Device XC886LM-6FF
Marking/Step ES AB
Package PG-TQFP-48

This Errata Sheet describes the deviations from the current user documentation. The module oriented classification and numbering system uses an ascending sequence over several derivatives, including already solved deviations. So gaps inside this enumeration can occur.

XC886/888CLM User's Manual	V0.3	Aug 2006
XC886/888CLM Data Sheet	V0.2	Oct 2006

Figure 1 Critical Cases for Power up/ Power down when $V_{residual} > 500mV$

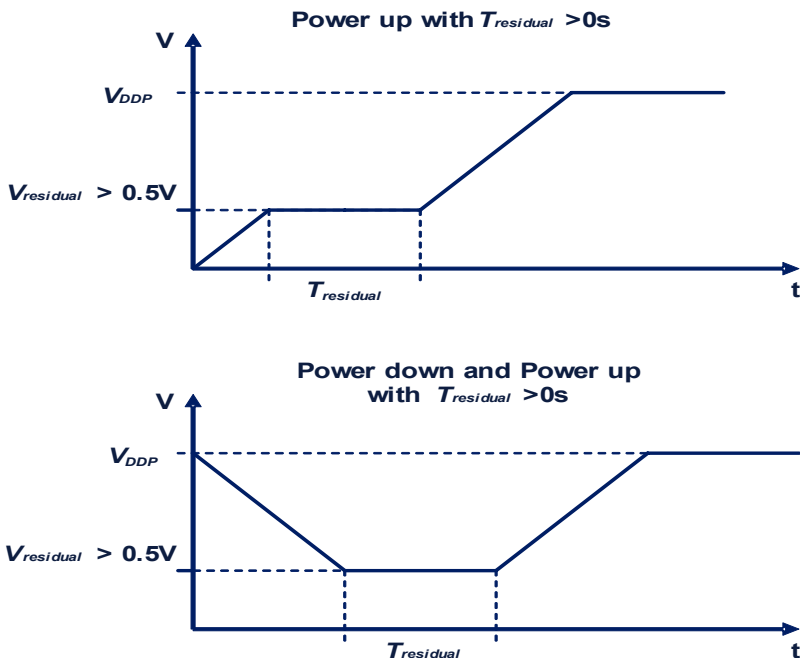
Due to the limitation of the EVR, the reset toggling may occur during the power up. To prevent the reset toggling issue for power up, the following conditions must be met :

1. For power up, the rising time must be less than $2\text{ms}/V$.
2. The power down time must be more than $0.2\text{ms}/V$.
3. A permanent V_{DDP} residual voltage is less than 500mV.

In case of V_{DDP} residual voltage is more than 500mV, the holding time of residual voltage affects the reset toggling issue. **Figure 1** shows the critical cases for power up/power down when the residual voltages is held for some time. **Figure 2** shows the uncritical case for power up and power down when the power up is triggered immediately after power down. In case of a residual voltage due to immediate power up after power down, the users have to contact IFX to ensure no power up failure.

Figure 3

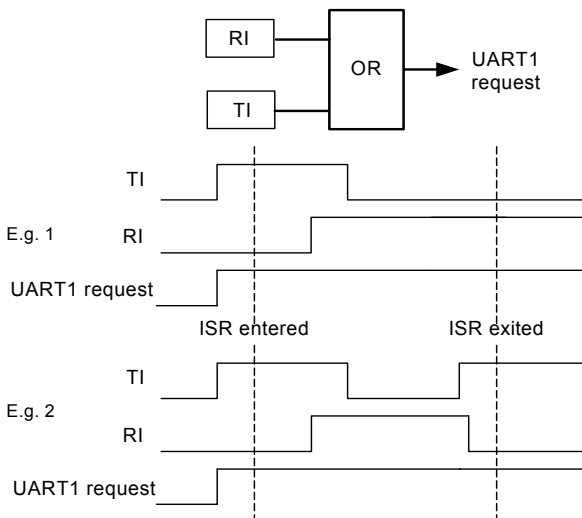
INT_XC8.004 Unable to Detect New Interrupt Request if Any One of Timer 2/UART1 Interrupt Flags Is Not Cleared (Unexpectedly)

As illustrated in the simplified figure, the UART1 interrupt flags RI and TI are combined as one interrupt request output. These flags are located within the UART1 kernel, with a single interrupt request line as output from the kernel.

Being of interrupt structure 2, the interrupt request of UART1 is detected on the rising edge of a positive pulse.

The problem is that it may occur at some point in the application, that any new UART1 interrupt request can no longer be detected after a return-from-interrupt (reti) due to service of earlier event(s). This happens when the following conditions are true:

1. UART1 events are serviced by interrupt (i.e. flags are checked and cleared only in the interrupt routine ISR),
2. Either RI or TI is set at any one time throughout the ISR (even while the other is cleared) such that at least one of the flags is still set after reti, causing the UART1 request line, which is an OR-function of the two flags RI and TI, to remain set throughout the ISR and after reti.

There are two suggested workaround:

1. If other events of interrupt node XINTR8 (EX2) need not be enabled for interrupt, disable this interrupt node and use software polling of the flags instead.
2. Before return from interrupt, check again if RI or TI is (still) set (due to new request since the last check). If so, jump and execute the ISR routine from start. Exit only when all flags are checked to be cleared. However, dummy

interrupt of the node may occur after return from interrupt, and should be ignored. Another drawback is if UART1 events are occurring at high rate, the CPU may be 'stuck' in the service routine of the UART1 interrupt for a long time.

Figure 7

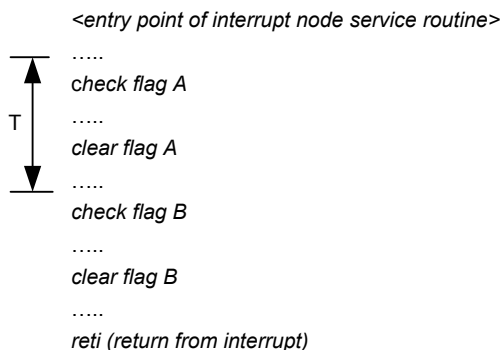
INT_XC8.H004 NMI Interrupt Request With No NMI Flag Set

It might occur in the application, that sometimes NMI interrupt requests are serviced, but no active NMI interrupt flags are found.

Consider the following NMI interrupt service routine pseudo-code, and scenario where a NMI interrupt source A event leads to interrupt request of the NMI node and CPU vectors to the NMI interrupt routine. Meanwhile, NMI interrupt source B and its flag becomes active any time in the duration indicated by T:

In this case, NMI flag B will be cleared as a standard procedure by the NMI interrupt routine in the current service. However, the pending interrupt request for the NMI node remains activated after RETI, as it is only cleared by hardware when CPU acknowledge the NMI interrupt and vectors to the NMI service routine.

This leads to following servicing of the NMI interrupt node again, but potentially no active NMI flag is found, i.e. dummy NMI interrupt service. The point to note is that the NMI interrupt source B is not lost, as it was actually serviced in the current service of the NMI interrupt node.

The recommendation is to ignore these dummy NMI interrupt vectoring.
